TECHNICAL SERVICE BULLETIN

Equipped With Subwoofer - Rattle From Right Loadspace Trim Panel At High Audio System Volumes - Built On Or Before 20-Mar-2023

23-2241
27 July 2023

Ford 2021-2023 Bronco	Built on or before 20-Mar-2023 Equipped with a factory subwoofer
---------------------------------	---

Figure 1 - 3-Door Shown, 6 tree fasteners must be replaced

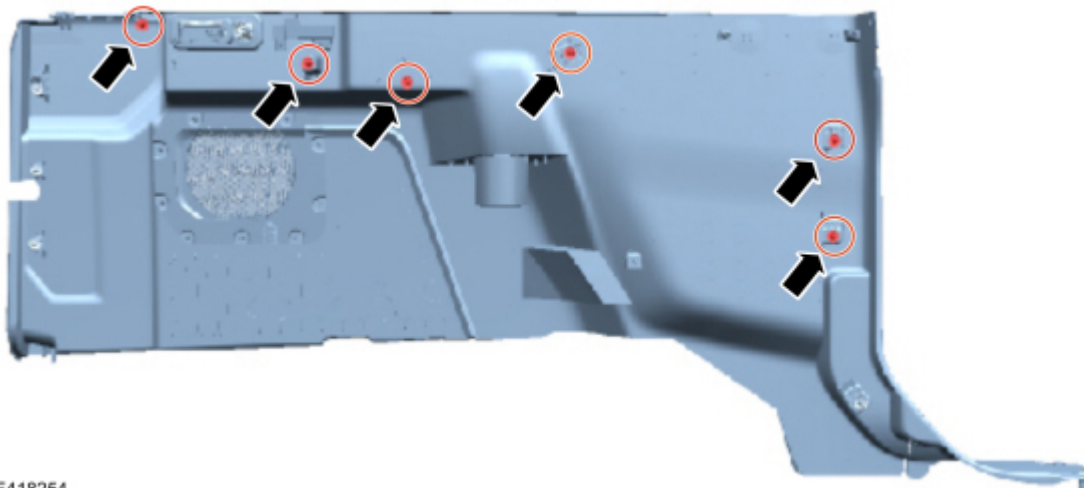
1. Remove the right loadspace trim panel. Refer to the Workshop Manual (WSM), Section 501-05.
2. Remove and discard the existing tree fasteners on the right loadspace trim panel then install the new tree fasteners. 3-door vehicles require replacement of 6 tree fasteners. 5-door vehicles require replacement of 5 tree fasteners. Refer to Figures 1 and 2 for fastener locations.

NOTE: The new tree fasteners will be blue in color.
